VERIFICATION REPORT VIÑALES BIOMASS POWER PLANT

Project Title	<i>Viñales biomass power plant</i>
Version	2
Report ID	VCS.VER.21.134

Report Title	<i>Verification Report – Viñales biomass power plant</i>
Client	<i>Maderas S.A.</i>
Pages	101
Date of Issue	29-Apr-2024
Prepared By	<i>Earthood Services Private Limited</i>
Contact	<i>Address: 1203-1205, 12th Floor, Tower B, Emaar Digital Greens, Sector 61, Gurugram, Haryana, India 122102</i>

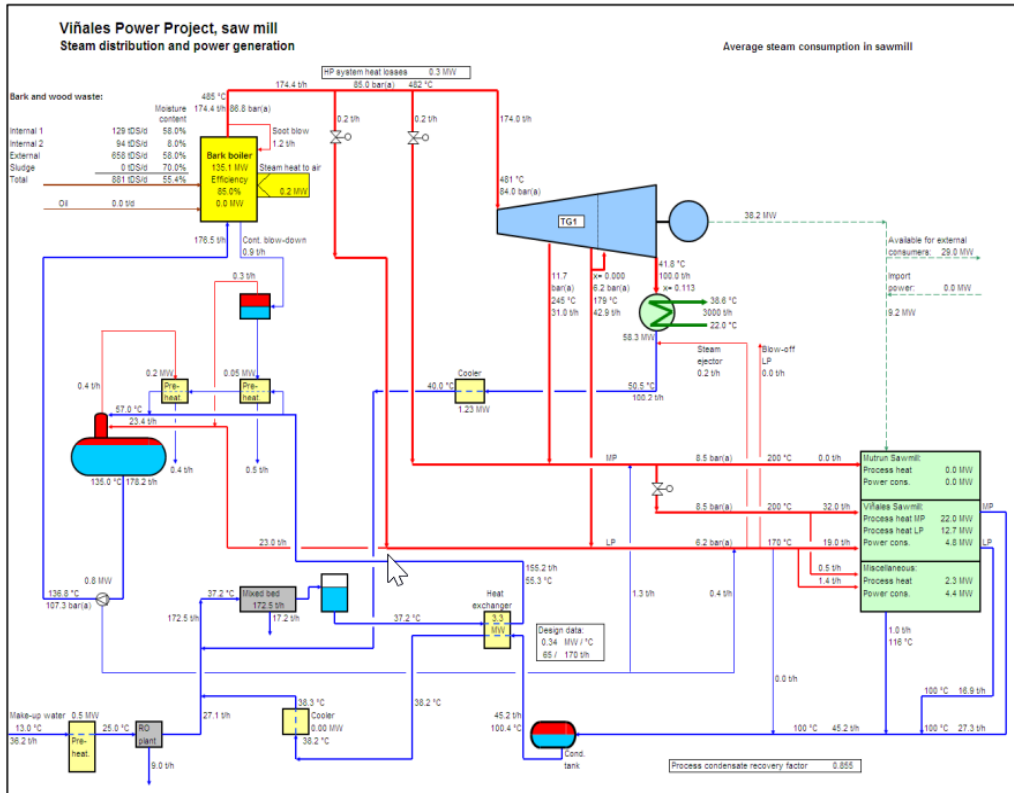
2. .
3. Although it has been observed that for 2018, the heat generator exceeded the total capacity of baseline heat generator and although applied value for the parameter CAP_{HG,h} has been corrected in accordance with PD section 4.1, the verification team observed that the total heat to process, which is the heat that would be required in the baseline scenario also took into account the high pressure heat (see ER calculations spreadsheet, tab emissions, row 129, which also adds row 120). Therefore the calculation remains inconsistent. **Issue remains open.**

CAR remains open due to issue #3 above

- The previous calculation had an error where the high pressure steam was mistakenly included as part of the process heat, alongside the medium and low pressure streams. To rectify this, the energy provided by the steam currents at medium and low pressure has been taken into consideration. You can refer to the cogeneration plant diagram for more information.
